Applicants : Dickson, Nicola J., et al.
Serial No. : Not yet assigned
Filed : Herewith By Express Mail (10.11.99)
For : CHROMATOGRAPHY COLUMN SYSTEM AND METHOD
OF PACKING OF A CHROMATOGRAPHY COLUMN
Examiner : Not yet assigned
Art Unit : Not yet assigned
Attorney
Docket No. : MCA-432

PRELIMINARY AMENDMENT

CHROMATOGRAPHY COLUMN SYSTEM AND METHOD OF PACKING OF A CHROMATOGRAPHY COLUMN

Fig. 5

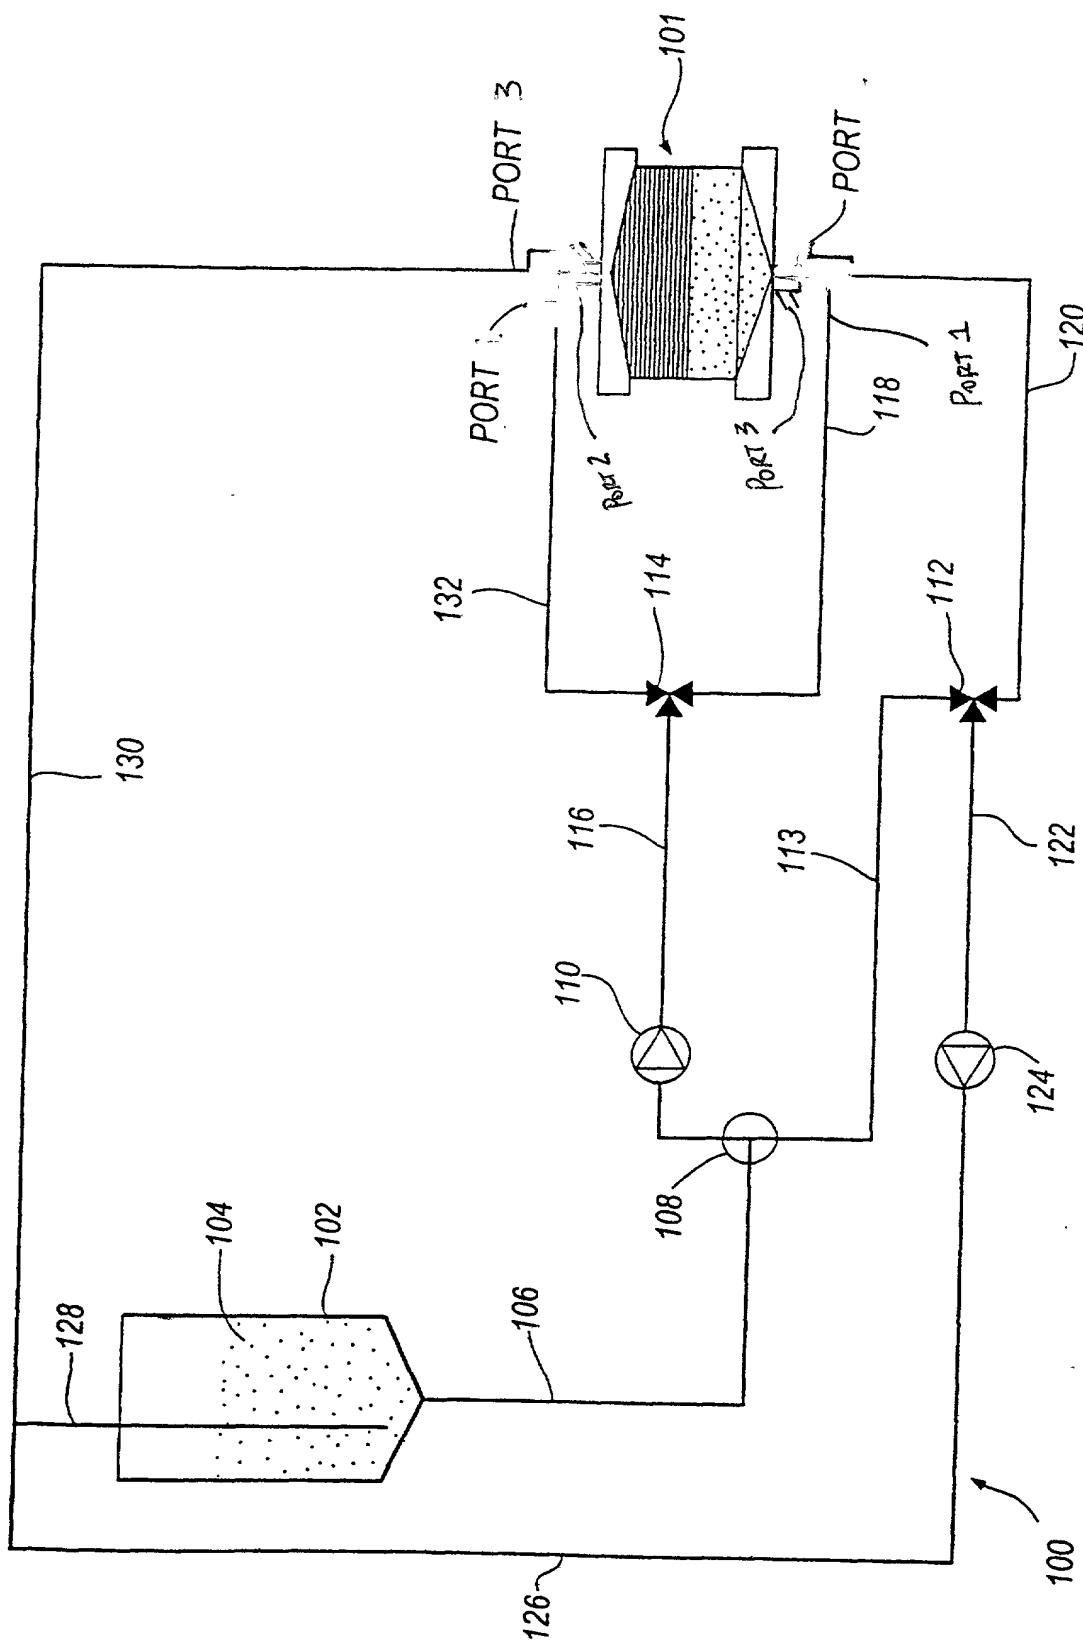
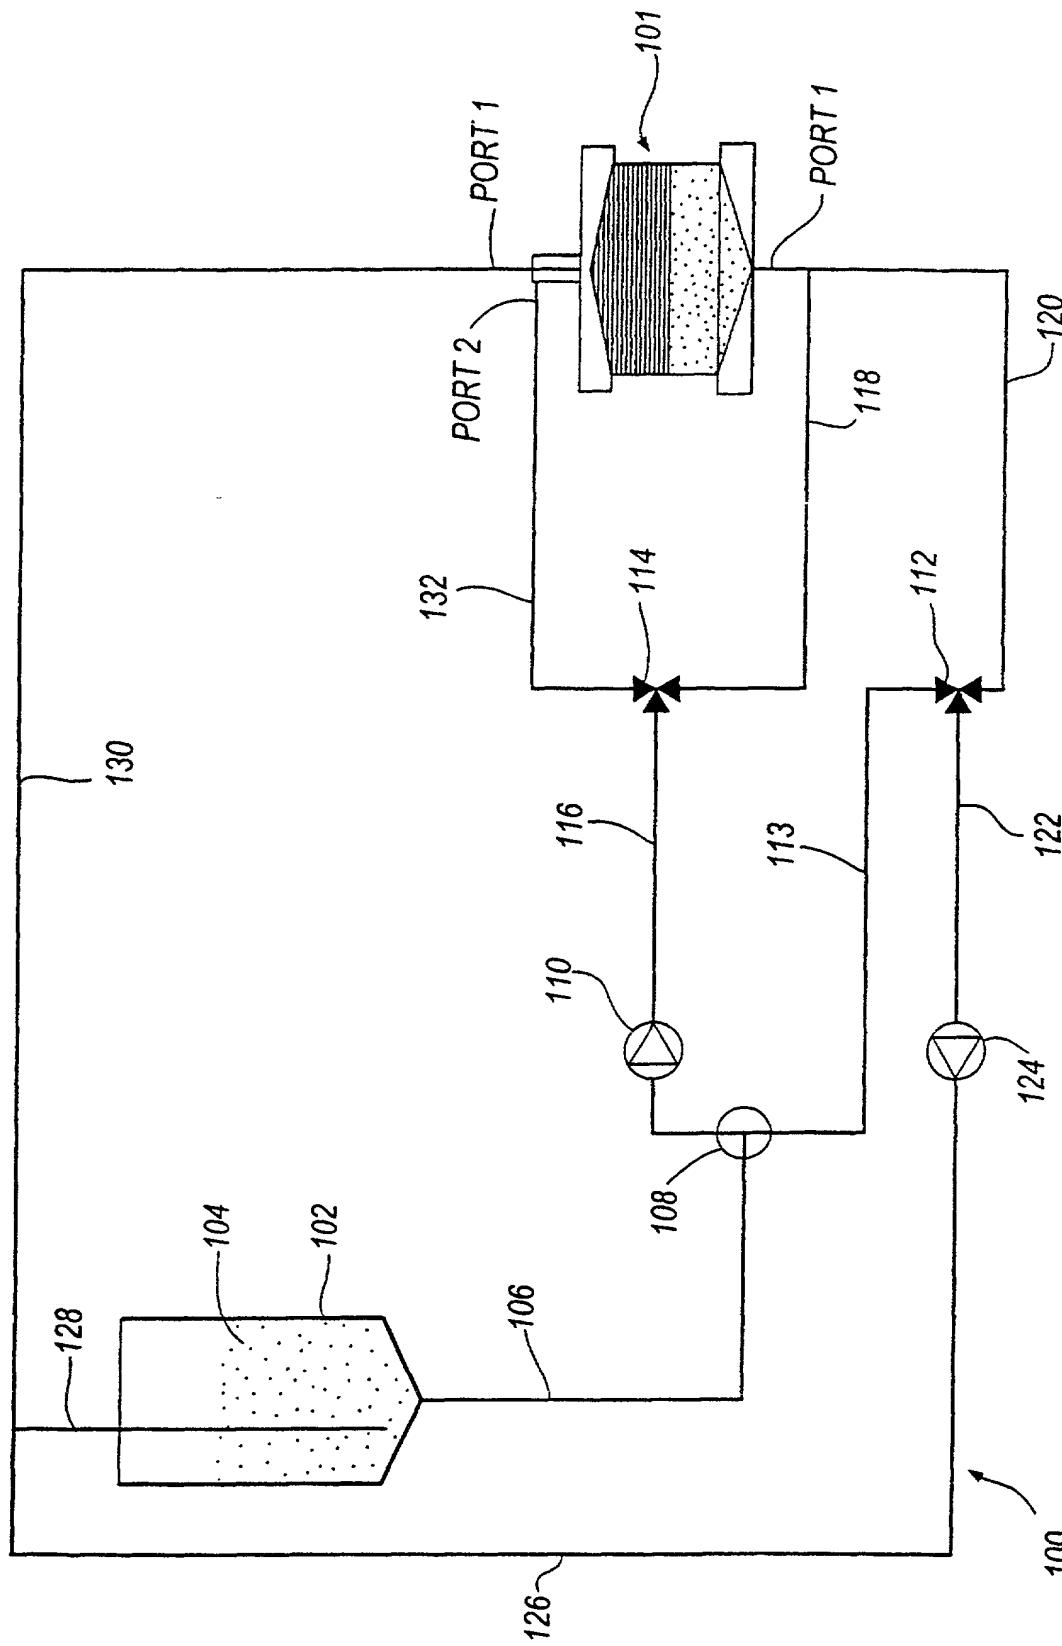
Figure 5 is amended to properly show ports 1, 2 and 3 in column 101.

Figure 5 as originally filed as obvious errors in that ports 1 and 2 of the top valve of the column 101 should be labeled as ports 3 and 1, respectively. The description makes it clear that packing is effected via port 1 and excess liquid from packing is removed via port 3.

to the other Figures (as set out above)(see page 20, last line and following), but it can be seen that Figure 5 as originally filed is obviously incorrect in the ports and their connections.

The foregoing amendment therefore corrects Figure 5 by labeling column 101 as having 3-port valves; by showing that the excess liquid obtained during packing exits port 3 and is returned to the slurry vessel via pipe 130; and by showing that the slurry pump 110 can feed slurry to port 1 of either column valve (selected by 3-way valve 114), so pipe 132 is now shown connected to port 1 of the top valve, and the separate connections of pipe 118 and 120 to ports 1 and 2 of the lower valve are now explicitly shown.

The output of the packing pump 110 is coupled to a 3-port valve 114 by a pipe 116 and from there to port 1 of the valve at the base of the chromatography column 101 by a pipe 118. The 3-port valve 112 is also coupled to a pipe 120 which is coupled to port 2 of the valve at the bottom of the chromatography column 101 and by a pipe 122 to a circulating pump 124 whose output is coupled to a pipe 126 and hence to the slurry vessel 102 via a pipe 128.

Upper port 3 of the chromatography column 101 is coupled to a pipe 128 by a pipe 130. Upper port 1 of the chromatography column 101 is coupled to the 3-way valve 114 by a pipe 132.

Upper port 3 is opened during packing so the excess fluid is returned to the slurry vessel 102 via pipes 130 and 128 rather than being taken to a waste vessel for other storage vessel. This acts to dilute the media particles in the slurry 104 as packing progresses until all the particles have been retained within the column.
